CALIFORNIA INSTITUTE OF TECHNOLOGY
 Laser Interferometer Gravitational Wave Observatory (LIGO) Project

To/Mail Code: Stan Whitcomb
 From/Mail Code: Kent Blackburn
 Albert Lazzarini
 Phone/FAX: 395-3185/8444
 Refer to: LIGO-E960108-A-E
 Date: July 31, 1996

Subject: Closeout of COC DRR AI#11 -- Recommendation of parameter choices in 2 km interferometer design.

Figure 1: Best estimate $h[f]$ for initial 4 km LIGO interferometers

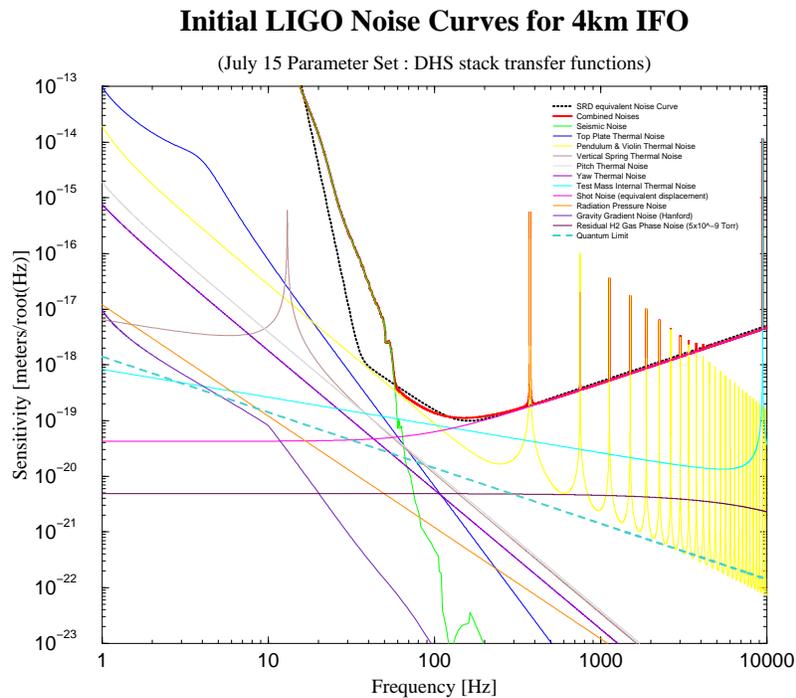
The options which were assessed were to either: (i) maintain IFO knee frequency the same as in the 4 km IFO; or (ii) to maintain the reflectivities in the 2 km IFO the same as in the 4 km IFO. Figure 1 presents the best estimate of the baseline strain sensitivity for the 4 km. Figure 2 shows $x[f]$ for the 2 km IFO in which the knee frequency is maintained at 90 Hz (option (i) above). Figure 3 shows $x[f]$ when the reflectivities are maintained the same as in the 4 km instrument (option (ii) above). The parameters used in calculating the three sets of figures are listed in Table 2.

Figure 2: Estimated $h[f]$ for initial 2 km LIGO interferometer with same storage time as 4 km.

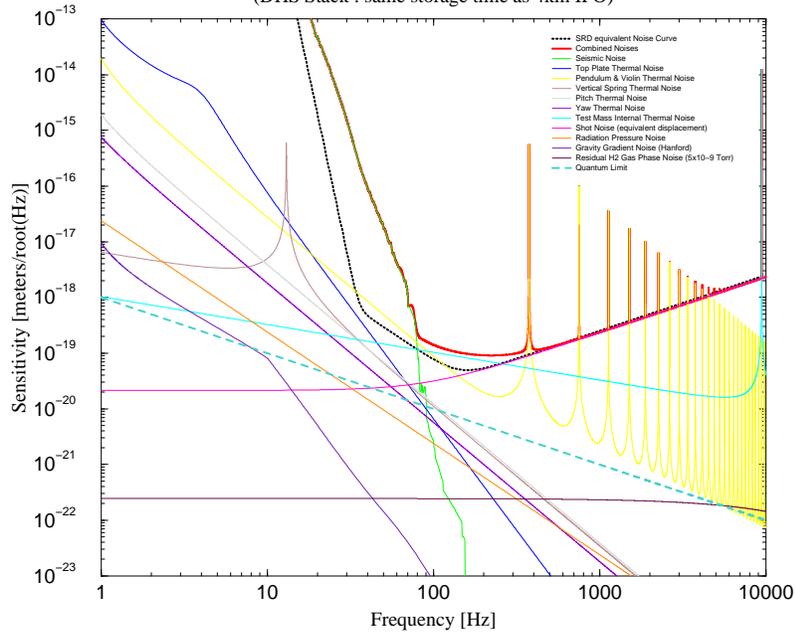
Comparison between Figures 2 and 3 indicates that while the shot noise component of $h[f]$ @100 Hz for option (ii) is almost 2x greater than it is for option (i), this effect is masked for both options (i) and (ii) by the fact that the internal thermal noise is greater than shot noise by factors 3.3x and 2.5x for options (i) and (ii) respectively. This arises from the smaller beam spot dimensions for a 2

The recommendation is to maintain the same mirror reflectivities in the 2 km IFO as in the 4 km IFO, thereby leading to (a) mirror irradiances in the 2 km system that are 2.5x and 1.6x greater (for end and vertex masses, respectively) than in the 4 km IFO and (b) a knee frequency of approximately 180 Hz.
